# TECHNICAL SERVICE BULLETIN

Technical Service Bulletin: 410-1598

Forest River is alerting you to an issue involving certain 2021-2023 Columbus Fifth Wheel recreational vehicles. Please see the information below which describes the issue and provides you with details on the steps you should take to have your vehicle repaired.

# TECHNICAL SERVICE BULLETIN 410-1598 REMEDY INSTRUCTIONS

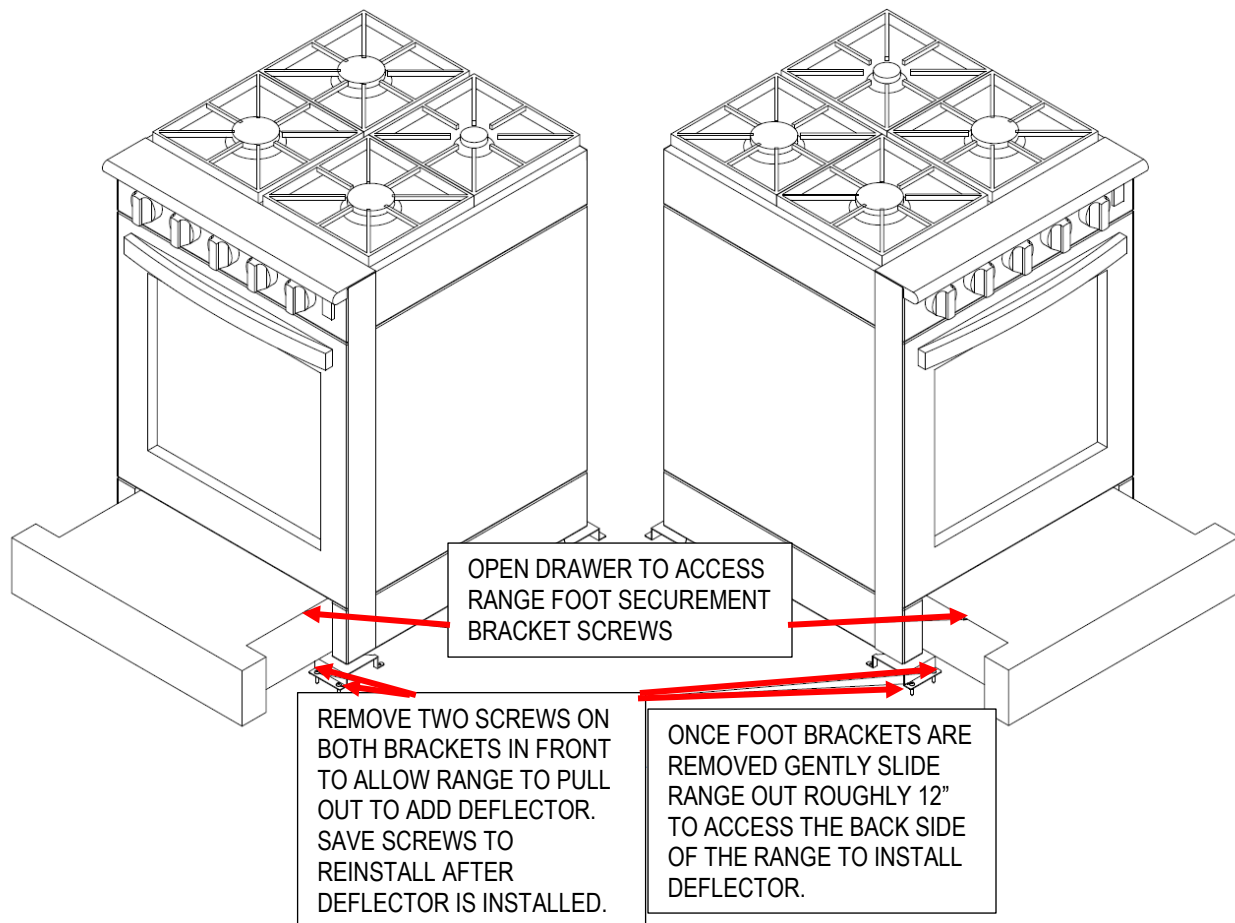
Concern:  
 Install a deflector to help prevent warping of the backsplash from the heat of the range.

STEP 1: PULL OUT THE DRAWER UNDER THE RANGE TO ACCESS THE SCREWS OF THE FRONT RANGE FEET BRACKETS;

STEP 2: REMOVE THE TWO SCREWS FROM EACH RANGE FRONT FOOT BRACKETS TO ALLOW RANGE TO BE MOVED AWAY FROM THE WALL ABOUT 12" OR SO TO ALLOW ACCESS TO THE TOP SCREWS ON THE BACK OF THE RANGE. BE SURE TO SAVE THESE SCREWS FOR REINSTALLATION AFTER PLATE IS INSTALLED;

STEP 3: USE CAUTION WHEN SLIDING THE RANGE OUT NOT TO DAMAGE THE LINOLEUM ON FLOOR WITH THE FEET OF THE RANGE;

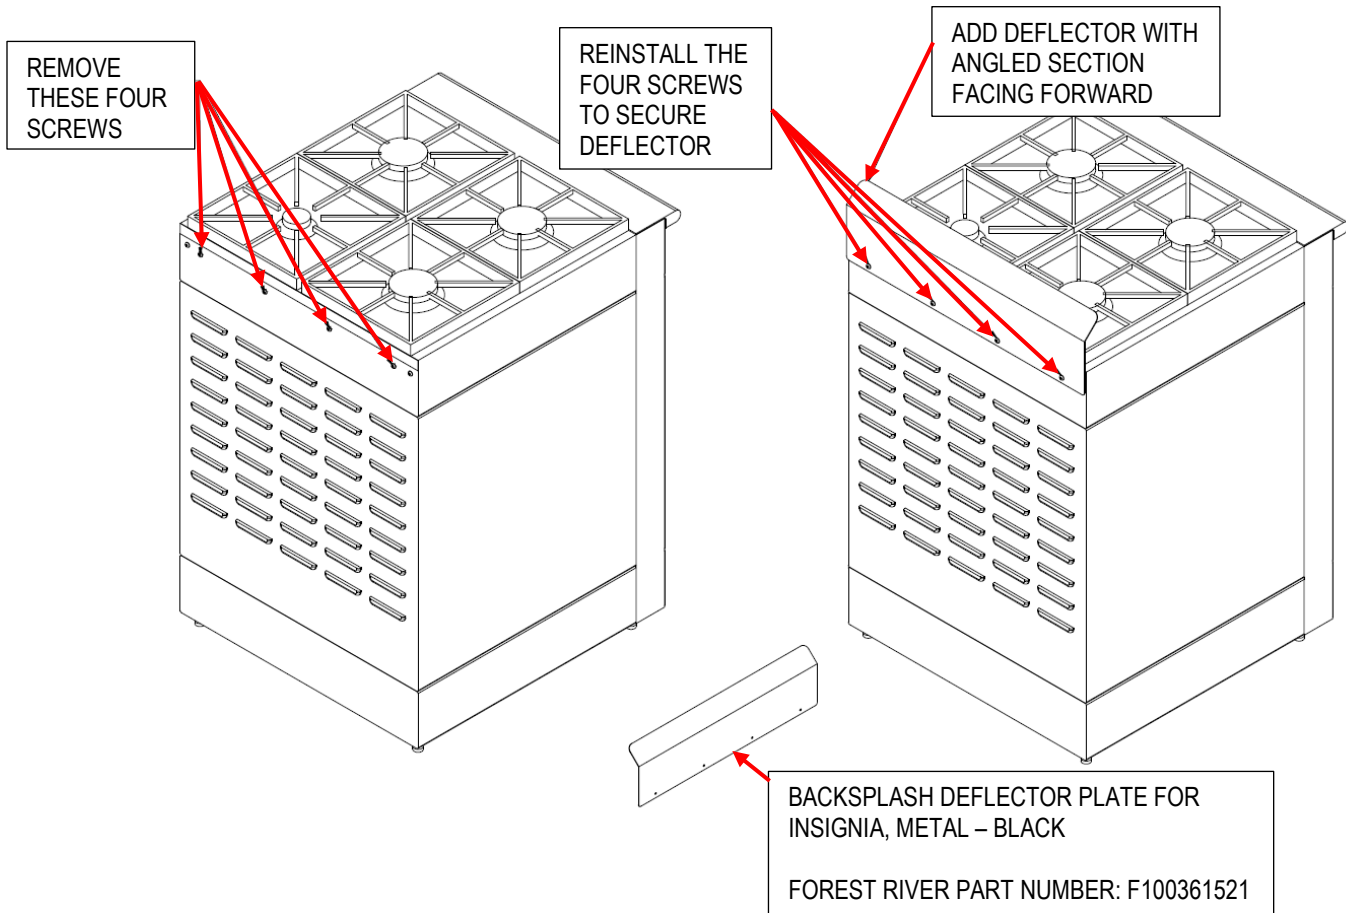
Concern:  
Install a deflector to help prevent warping of the backsplash from the heat of the range.

STEP 4: REMOVE THE FOUR CENTER SCREWS (LEAVING THE OUTER 2 SCREWS) ON THE REAR TOP EDGE OF THE RANGE;

STEP 5: ORIENT THE DEFLECTOR PLATE WITH THE ANGLED SECTION TO THE TOP AND FACING TOWARDS THE FRONT OF THE RANGE AS SHOWN IN THE DIAGRAM BELOW;

STEP 6: LINE THE HOLES IN THE DEFLECTOR PLATE WITH THE 4 HOLES THAT YOU JUST REMOVED THE SCREWS FROM AND REINSTALL THE SCREWS TO HOLD THE HEAT PLATE ON TO THE BACK OF THE RANGE;
